Awareness of the Proximity of Vulnerable Road Users:**UN Regulation No. 167 (Vulnerable Road Users Direct Vision)****Proposal for the 01 series of Amendments to the Original Version of UN Regulation No. 167 (Vulnerable Road Users Direct Vision)****Submitted by the expert from the United Kingdom of Great Britain and Northern Ireland ***

The text produced below was prepared by the expert from the United Kingdom to amend UN Regulation No. 167 for Vulnerable Road Users Direct Vision as adopted at the 188th session of the World Forum for Harmonization of Vehicle Regulations (WP.29) by ECE/TRANS/WP.29/2022/140/Rev.1. The modifications to the current text of the UN Regulation are marked in bold for new or strikethrough for deleted characters.

"Figure 1 Definition of the Assessment Volume, Based on a Category N₃ Vehicle as an Example

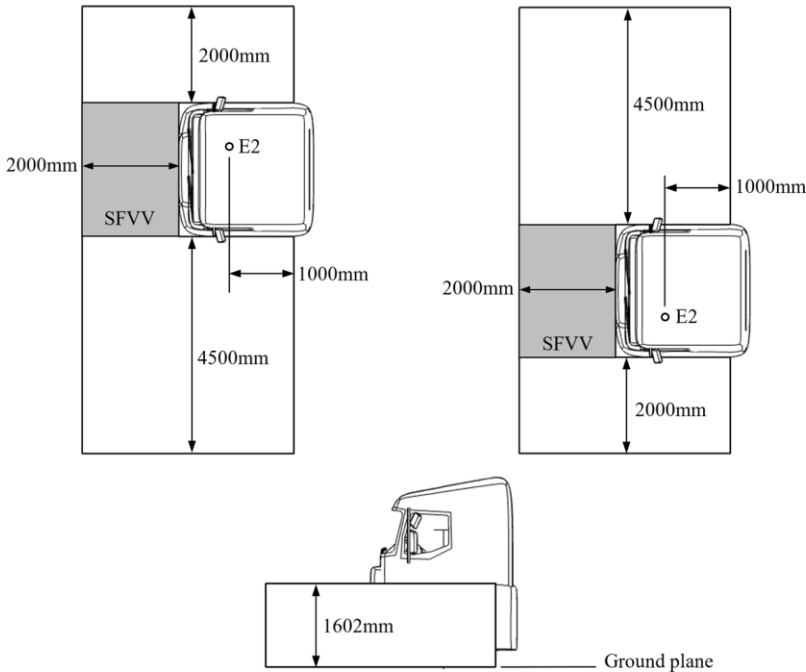
Annex 4, Figure 1, amend to read:
